**Responses to NRC Letter Dated August 19, 1997 and December 5, 1997, Regarding NRC
Acceptance Review of the Reclamation Plan for the White Mesa Uranium Mill**

**Source Material License SUA-1358
Docket No. 40-8681**

**Response to Nuclear Regulatory Commission / White Mesa Mill Reclamation Plan
Comments Dated August 19, 1997
Source Material License SUA-1358**

**Response to Nuclear Regulatory Commission / White Mesa Mill Reclamation Plan
Comments Received December 8, 1997
Source Material License SUA-1358**

FIGURE 1

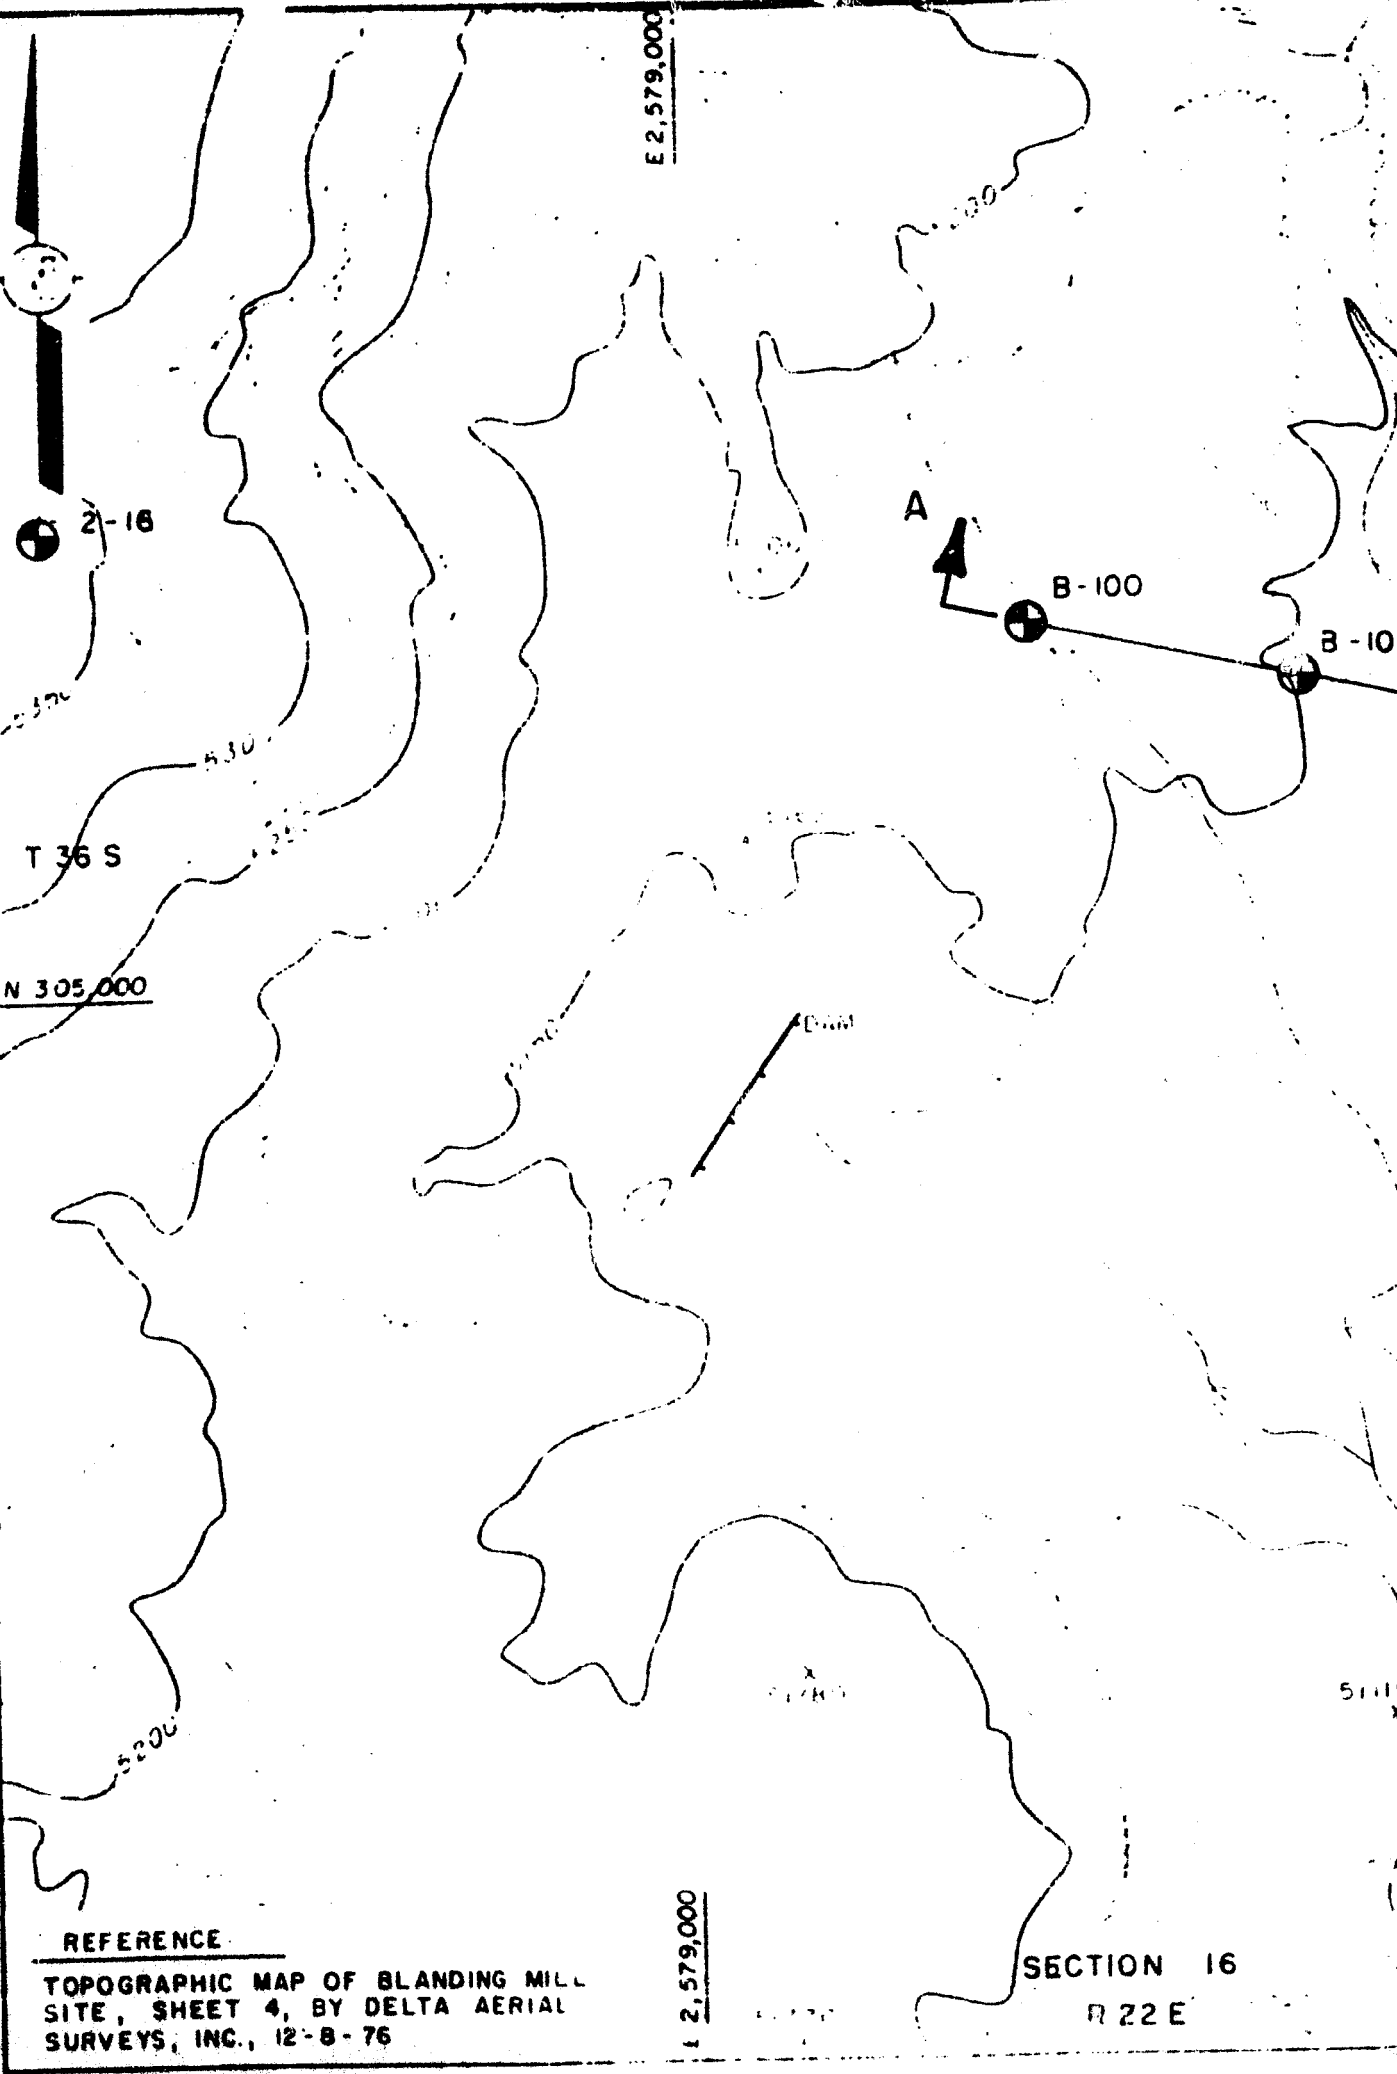
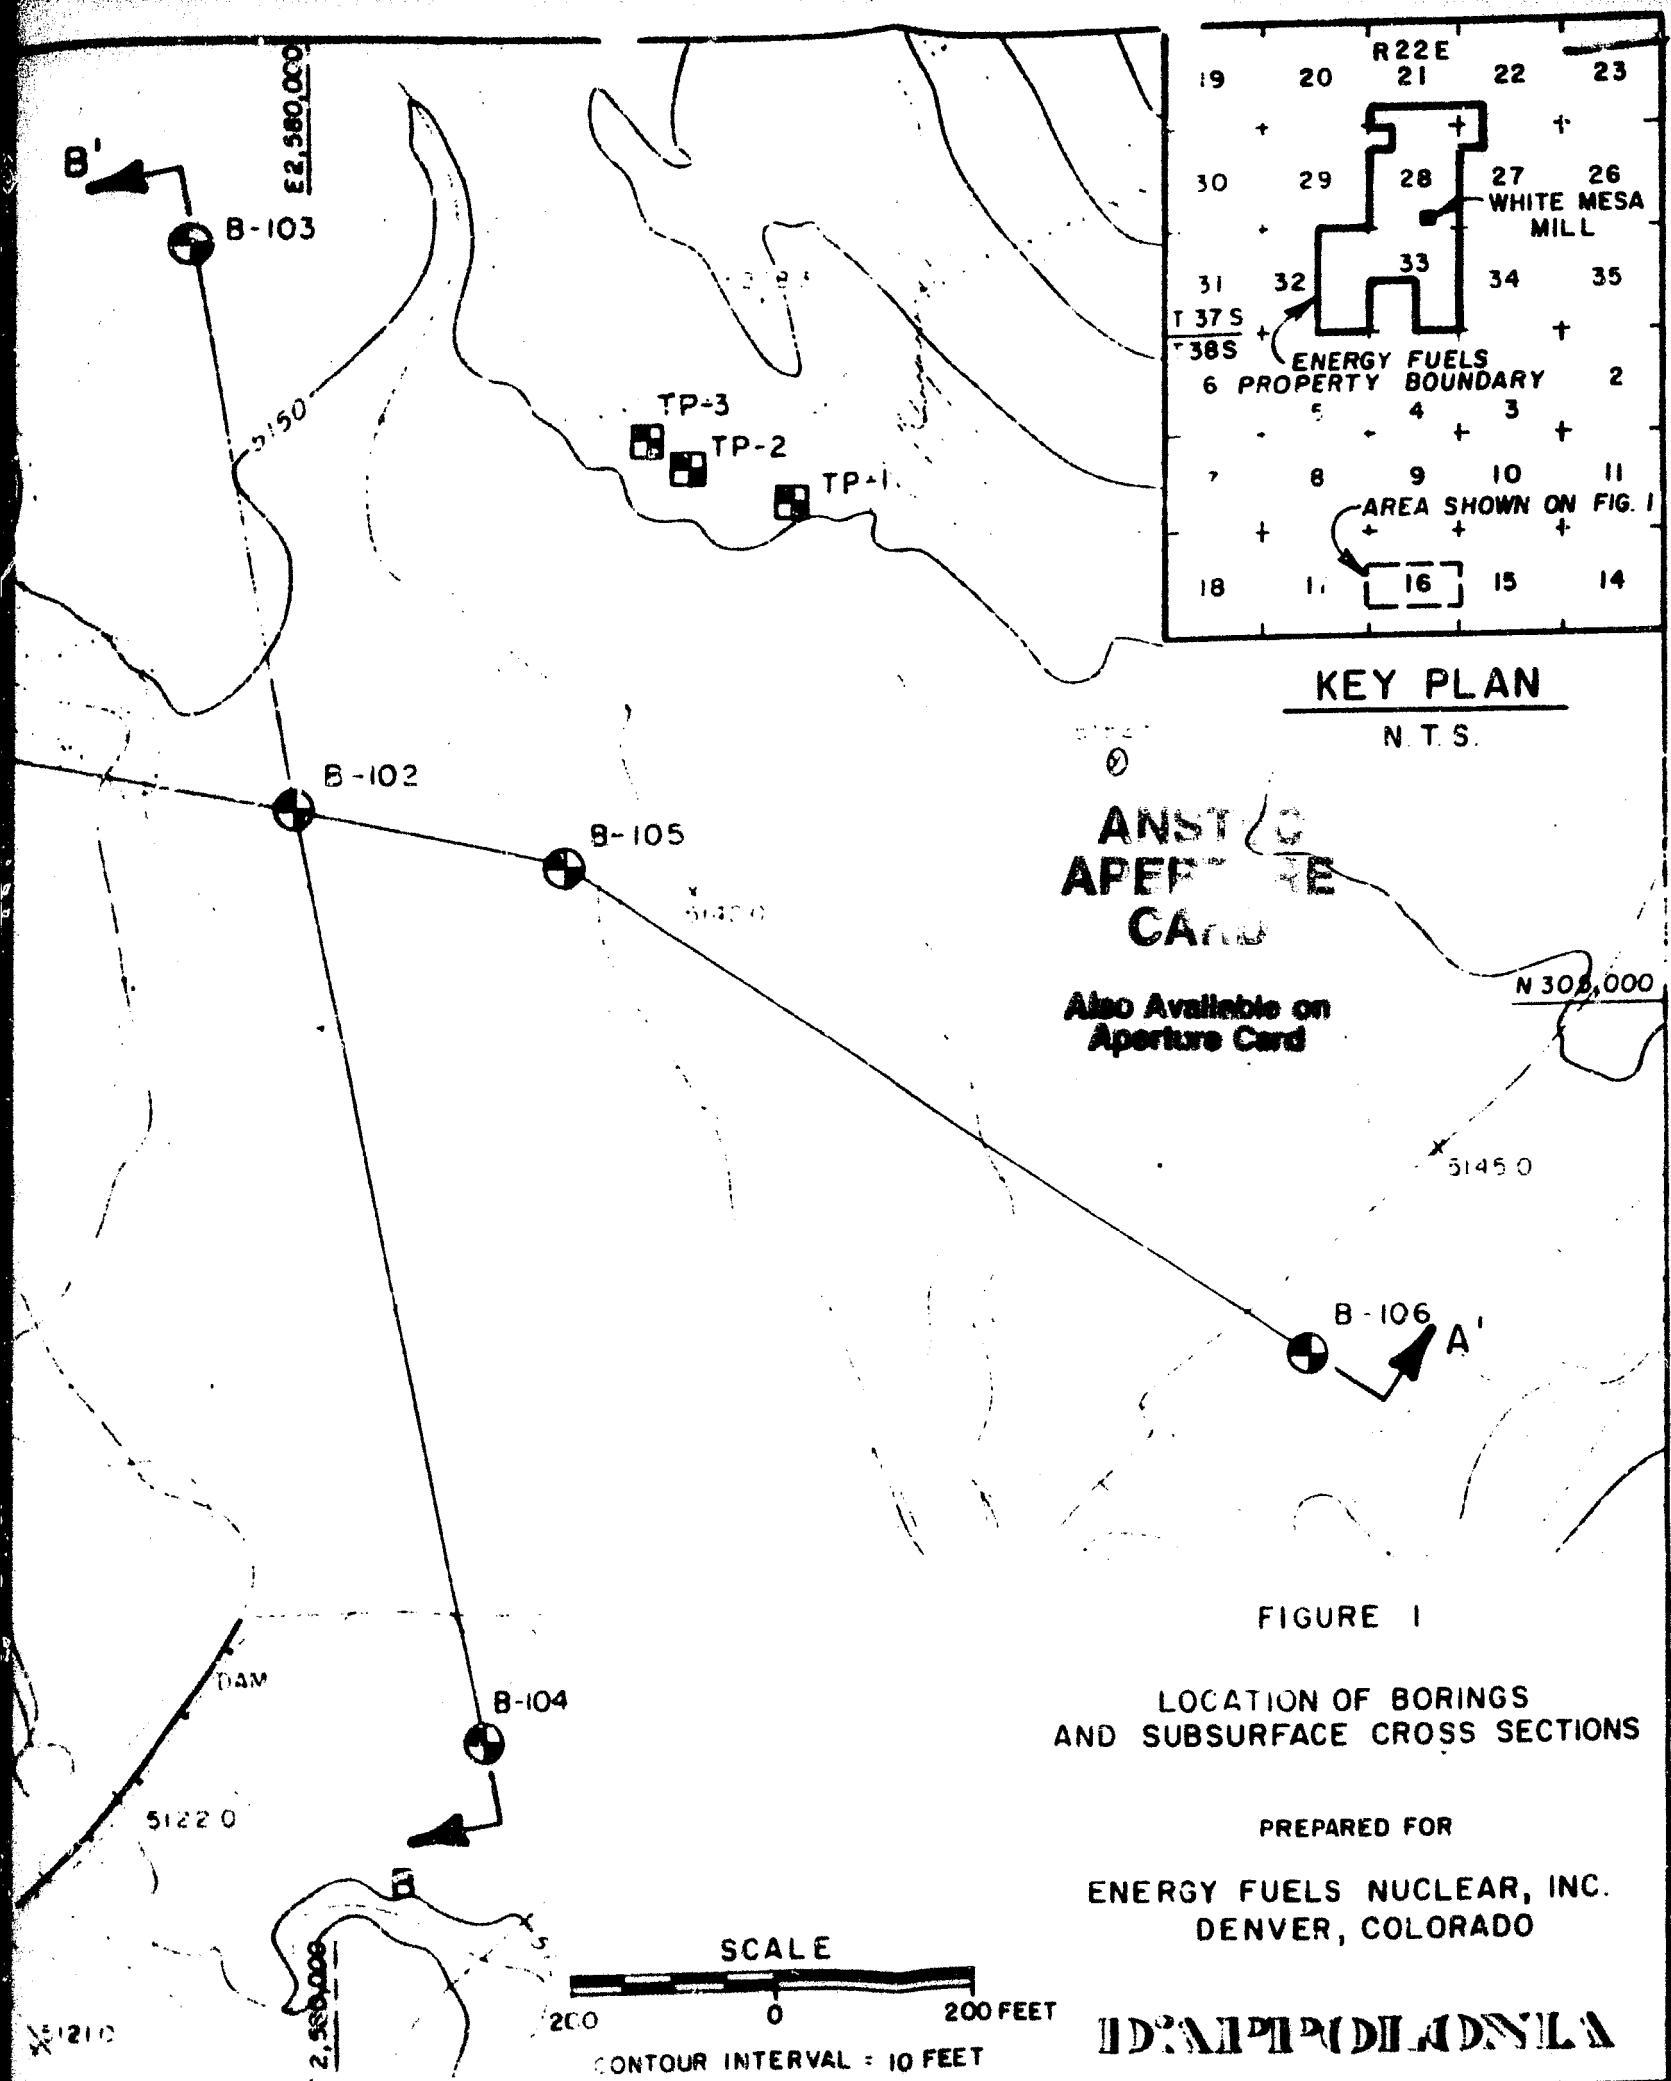
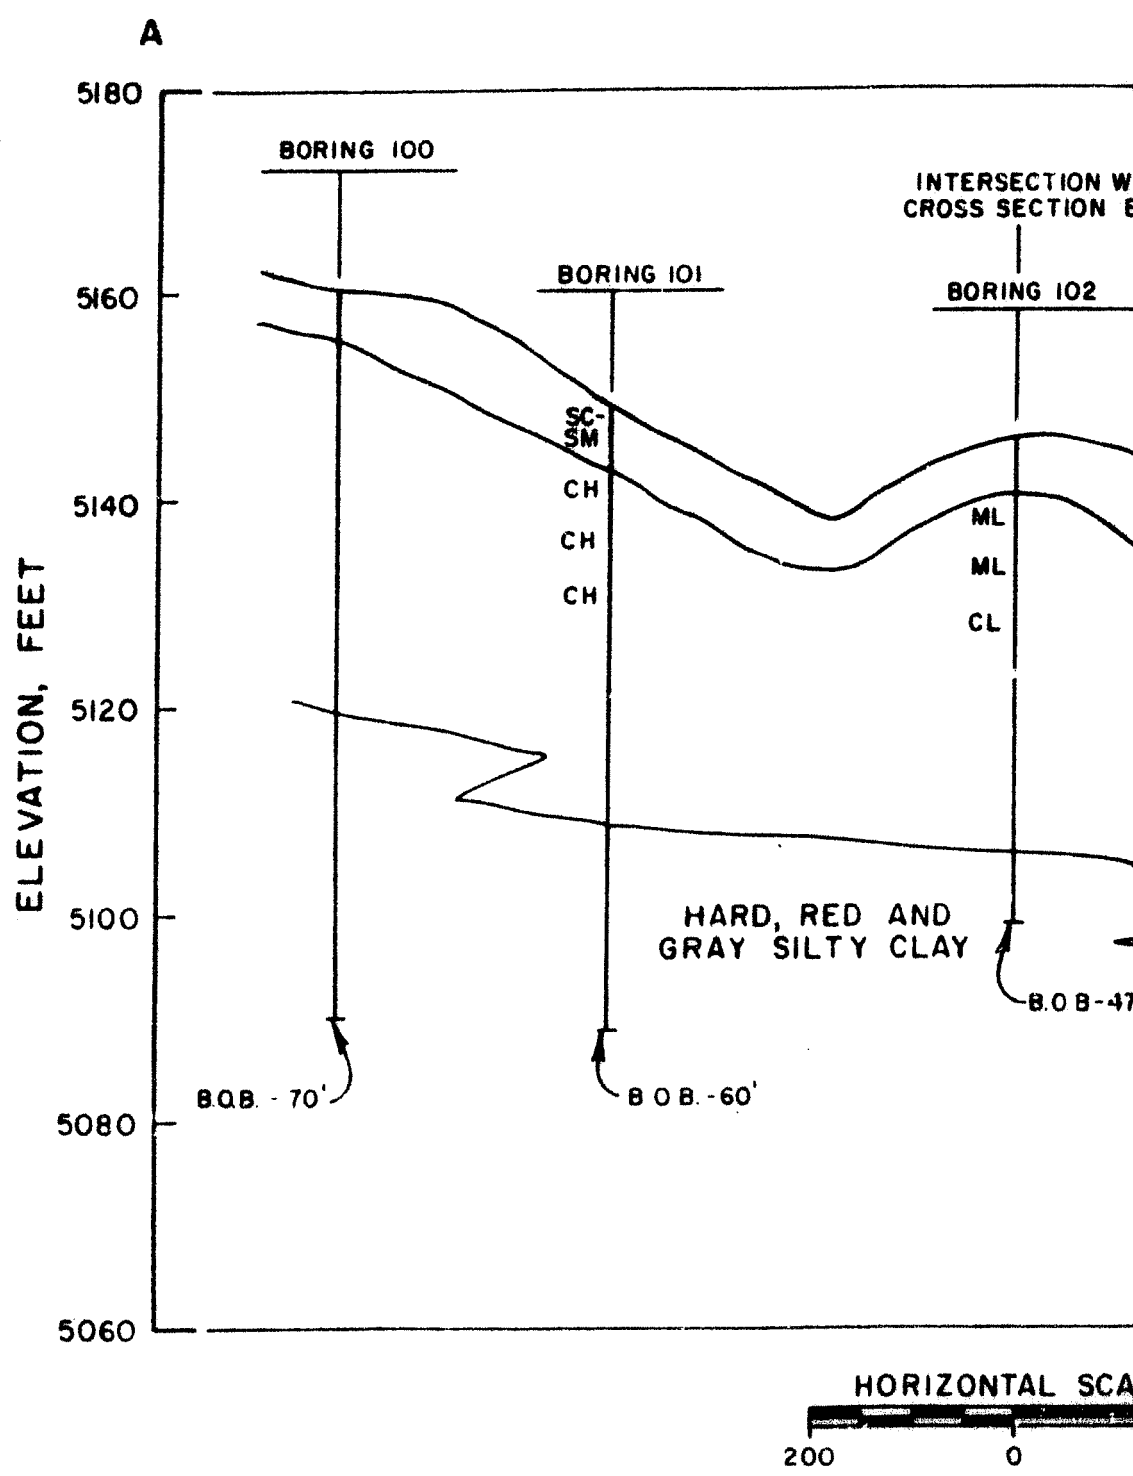
**(1) Information to support a review of the acceptability of the radon barrier design.
Specifically:**

- (ii) *An analysis to show that each type of material is available in sufficient quantity*

The clay materials were identified in the Section 16 area encompassed by borings B-100, B-103, B-104 and B-106 as shown on Figure 1 contained within Attachment 1 of this response. The surface area between these borings is approximately 1,160,000 square feet. The average depth of CL and CH materials encountered in the seven borings is approximately 44 feet as indicated on Figure 2 contained within Attachment 1 of this response. Based on the surface area and average depth estimated from Figures 1 and 2, the quantity of clay material available is approximately 1.8 million cubic yards.

The area of investigation is a canyon located in Section 16, about three miles south of the mill site. Seven borings were drilled as part of the field investigations. These borings, 100 through 106, are located approximately as shown on Figure 1.

Three test pits (1-3) were excavated to obtain bulk samples for laboratory testing. The location of the test pits is shown on Figure 1.

Samples from Boring 2-16 drilled by Energy Fuels in November 1978 were also provided to D'Appolonia for testing. The location of Boring 2-16 is shown on Figure 1.
